SERVICE BULLETIN #0013 Revision 1 Page 1 of 4

**SUBJECT:** Rudder Pedal Stop Replacement

MODELS AFFECTED: Sling LSA and Sling 2 - SIN 001-130 (Inclusive)

Figure 1 — Illustrates the covers to be removed

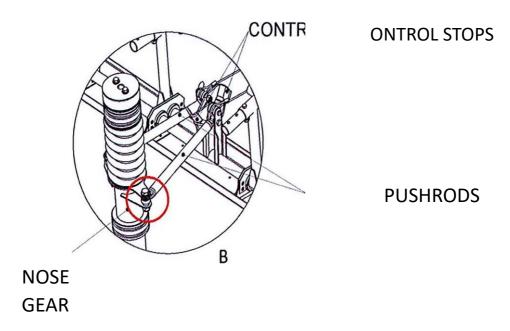
- 3. Remove inspection covers on both right-hand and left-hand side granting access to the rudder pedal stops using 2mm Allen key. (Figure 1)
- 4. Remove the pushrods from the nose wheel only by detaching the AN5 bolt with the <sup>1</sup>/2" spanner/ratchet respectively (Shown in Figure 2).
